**Report: REVIVE REPORT  
Function: Test, Adjust, & Balance  
Date: 03/10/2023**

**02-20-23 FREDDY'S - MCDONOUGH, GA  
(REVIVE)**

1410 HWY 20 W

**Issue Name :** 05 - ACPSP is dirty

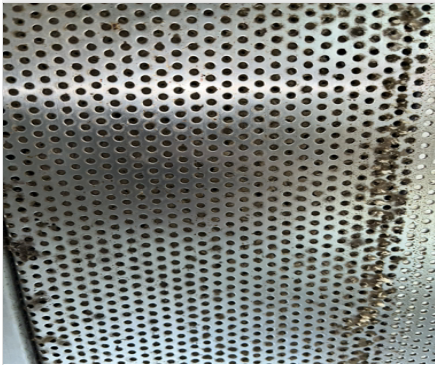
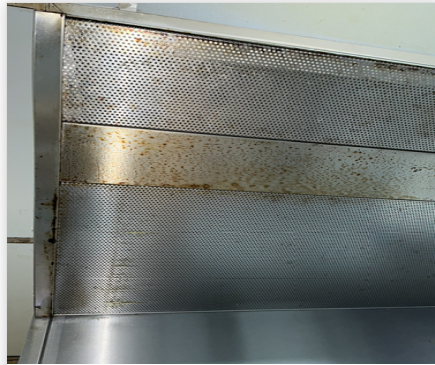
**Description :** Recommend dropping the AC-bsp portion and cleaning the top and bottom of the perforated grilles.
